Lewis River Fish Passage Subcommittee Meeting

**FINAL Meeting Notes
Lewis River License Implementation
Fish Passage Subcommittee Meeting
October 12, 2023
2:30 PM – 4:30 PM
MS Teams Meeting**

Capacity Comparison Presentation – 30% to 60% Design Changes

Yale Upstream Passage

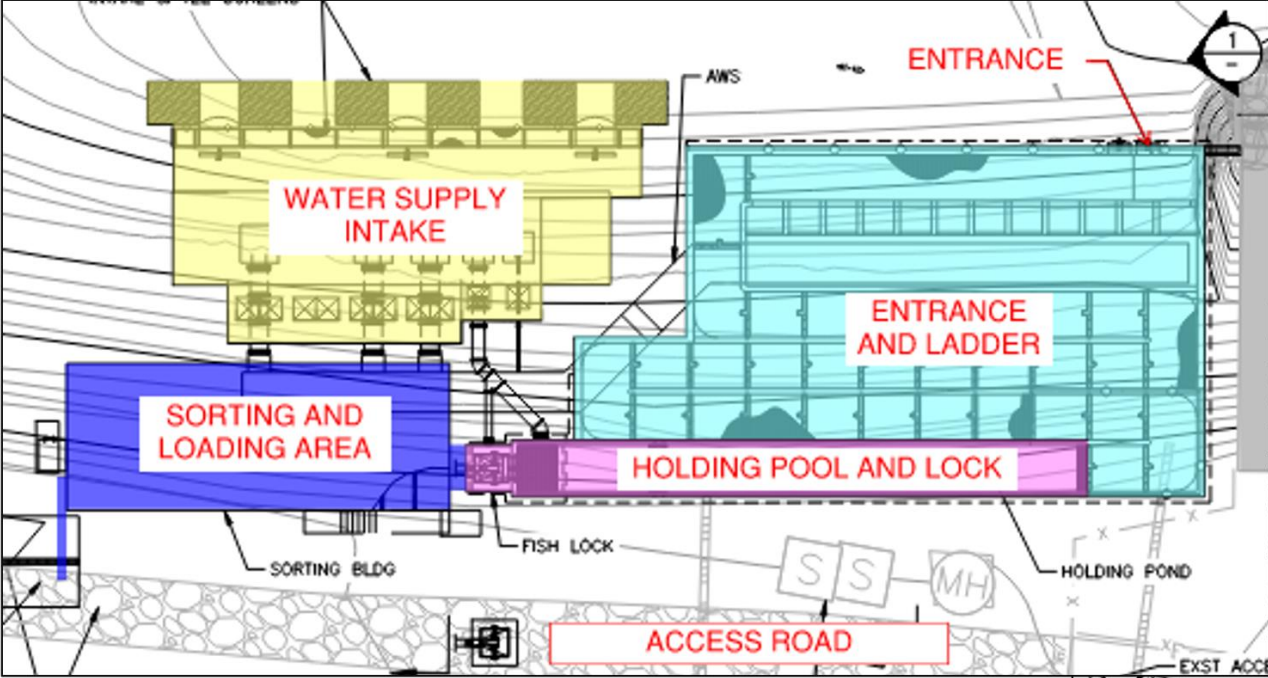
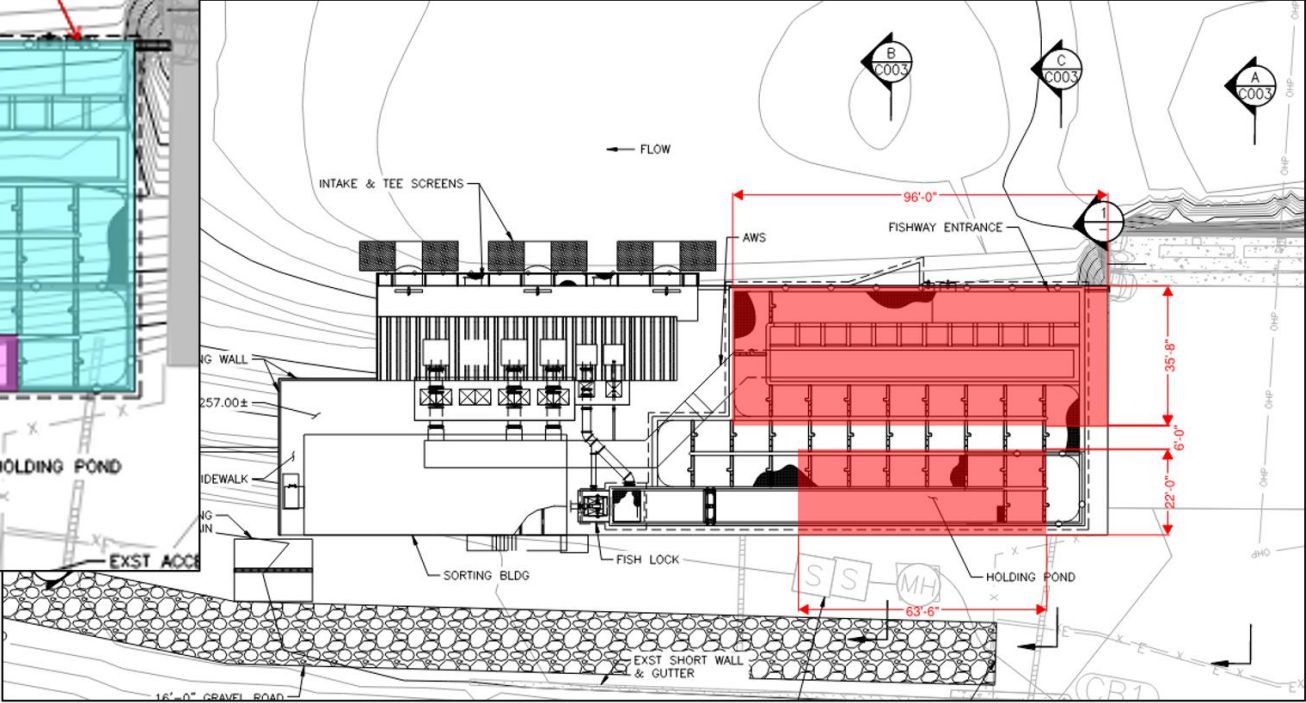
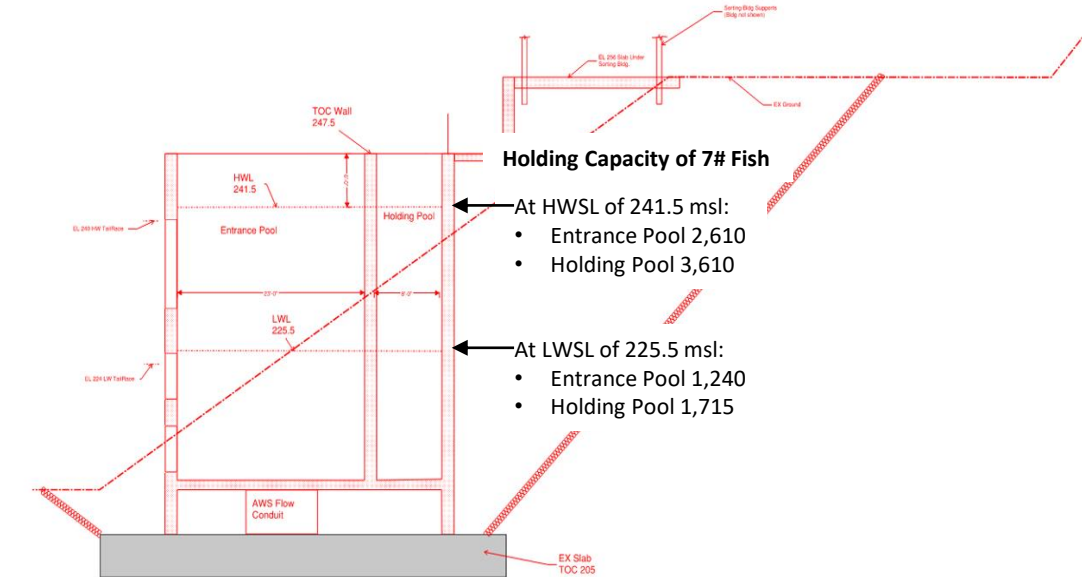
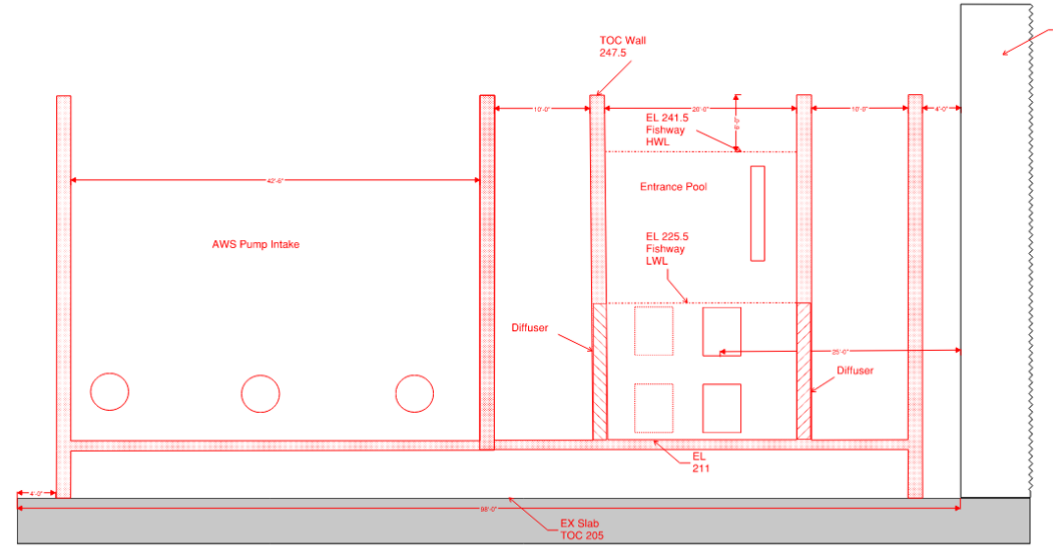
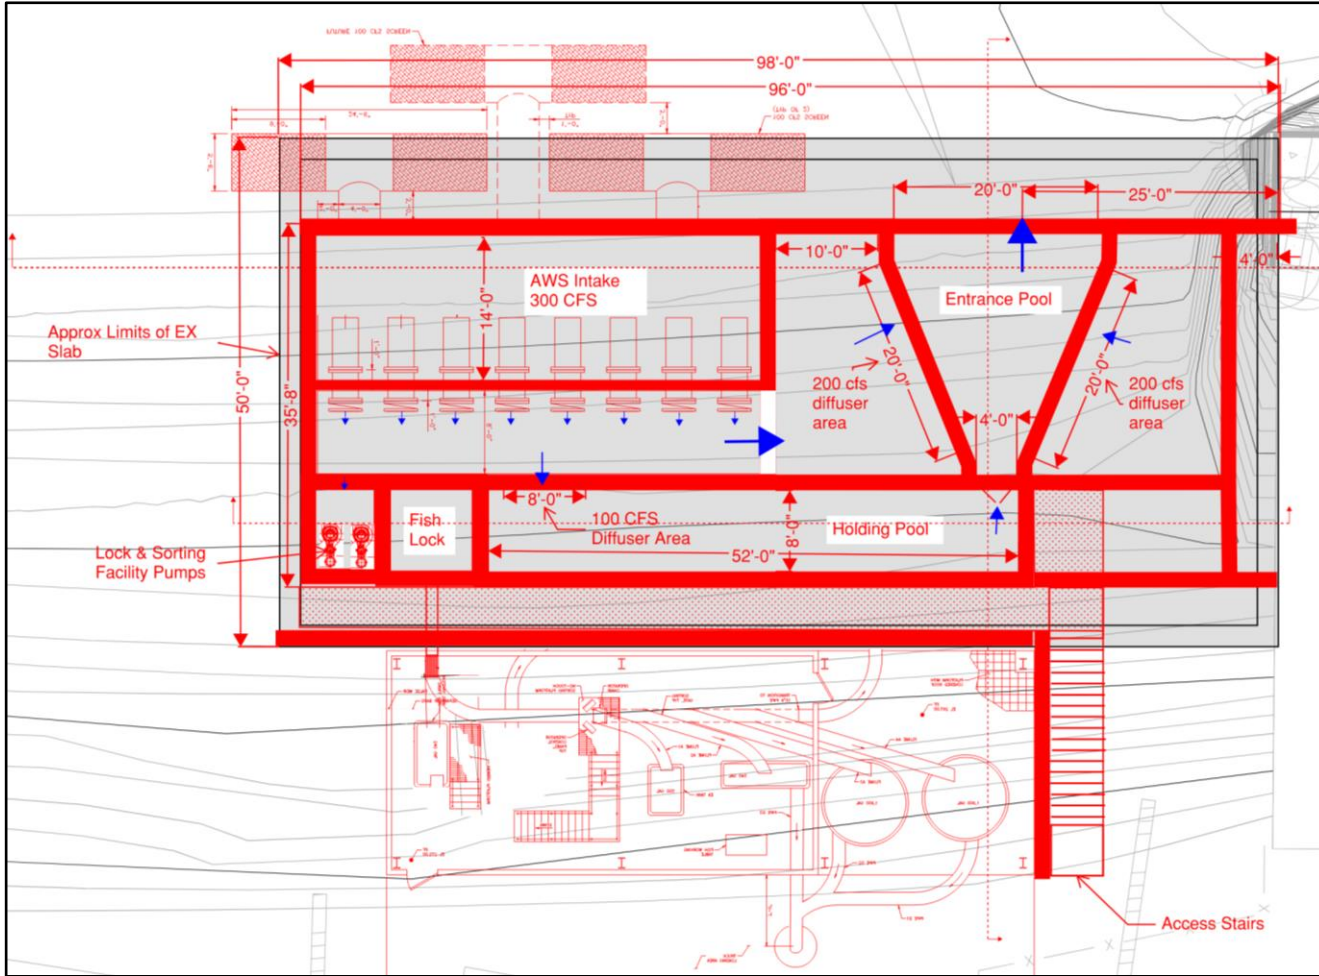
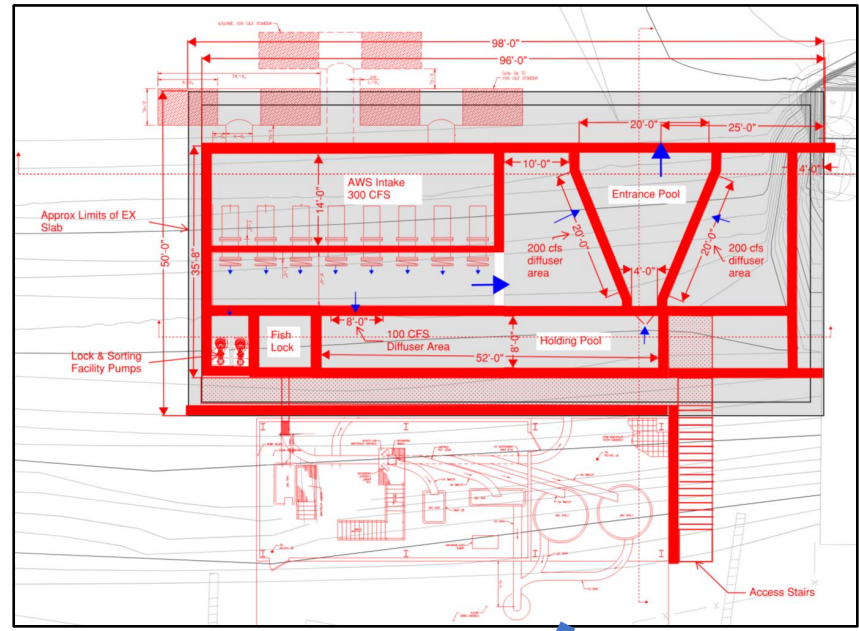
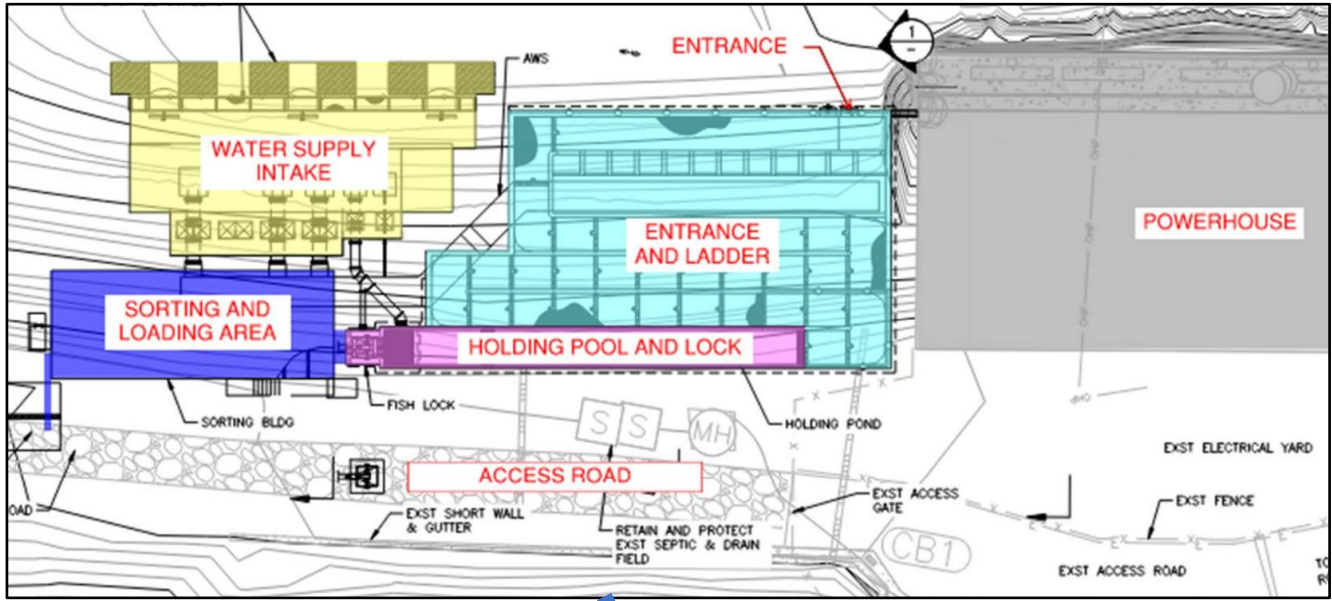
Glaser asked for better insight on how designs are changing and what that means for adult holding capacity of the upstream facilities. Karchesky indicated that the only changes to capacity occurred at the Yale upstream facility due to the change in how the fish enter and are initially held in the facility. Karchesky said that the big design change was to eliminate the long ladder and reduce the distance fish have to travel in order to reach the holding pool. Karchesky presented a walkthrough of how the configuration changed from the 30 to 60% design. Karchesky said that holding capacity has not changed for the Swift Facility from the 30% to 60% design.

Long fish ladders are a concern, so the design team took a closer look to see if there were ways to compress the area's footprint. We can take advantage of and use the existing infrastructure. The new design is easier on fish and fits well in the proposed location. It will have a horizontal crowder to push fish towards the fish lock. The new design allows for accommodating reservoir water fluctuations. Regarding the entrance portals, there is a slot in the upper wall portion (for salmonids) and low entrance points for bull trout similar to the previous design.

Glaser mentioned the size/capacity of facility to hold fish. In the original presentation, the ladder was significant; now it's not there. He said there is uncertainty with the elevation capacity. Under normal Merwin Reservoir operations, there will be the ability to hold over 6,000 adult 7-pound coho in the entrance and holding pools (more than four times the original design). Actual fish capacity is dictated by reservoir elevation. Glaser asked about a table of comparisons.

Pad Smith, WDFW, asked if the effective capacity was real and will fish occupy the whole space or will they orient at top or bottom. Karchesky said at the Merwin Fish Collection Facility they use the full space available. You still have oxygen capacity with volume. Smith then asked about the entrance and whether fish could be trapped in the holding pool. Karchesky said there are still some things to consider for the facility, one being the fishing position (v-trap entrance). At the Baker facility, they use v-traps at the entrances and can regulate it per fish abundance. If you get a lot of fish you can manipulate the entrance and how many fish are coming in at one time. Smith then asked when clearing fish from holding pool into lock, does the lock have the capacity of the entire holding pool? Also, does the sorting pool have the same capacity? Karchesky replied that the short answer no. The design intent is to operate much like the Merwin facility where there can be a high fish density in the holding pool and then metered into the lock. There will be water flow weirs to que fish to jump into the lock area and you can also use the crowder to move fish towards

Karchesky noted that at high reservoir elevations, the holding pool is bigger than the original design; it has quite a bit of room because we're taking out the ladder. It creates a big box. The lock system is taller. He thinks it's a more efficient approach. Glaser asked about reservoir operations. Todd Olson, PacifiCorp, said typical for this time of year, Merwin Reservoir is within the top five feet of pool elevation. Unlike Swift, a Merwin Reservoir drawdown impacts more recreation facilities and at 227 feet, we impact the Speelyai boat launch. When we think we are going to be at a low reservoir elevation, we advise the public. It's super rare to be at 225 feet for a maintenance event. Glaser added, so that would mean more often than not it would be at a higher holding capacity. Karchesky added it was a good challenge for the design team and was pleased with the revised design. Peggy Miller, WDFW, wondered if this design was lamprey friendly. Karchesky said it is more so than what we had with the fish ladders. There is flexibility if it's an issue and there are a lot of ways with the new design that you could address it. Smith asked if all the slots are open at the same time and are they managed the same way. Higa said the intention is to have a combination of upper slot and lower ports open. We haven't quite yet figured out the hydraulics. Karchesky added that the overarching intent is a jump style entrance and deep water slower entrance (carryover from the 30% design).

For the Swift upstream facility, it is unchanged from the 30% design. Glaser said the Yale upstream design is more elegant and he is happy with the fish capacity. As we get further along, he is thinking how the horizontal crowder is going to work. Melissa Jundt, NOAA, said in her mind she can see loading fish into the holding pool, and is concerned about moving parts and the mashing of fish because of operation, or they get underneath something. PGE style has the same infrastructure that we are planning. Karchesky agrees and has been discussing it with the design team. He will also look at the Clackamas facility. There will be more to come on this.
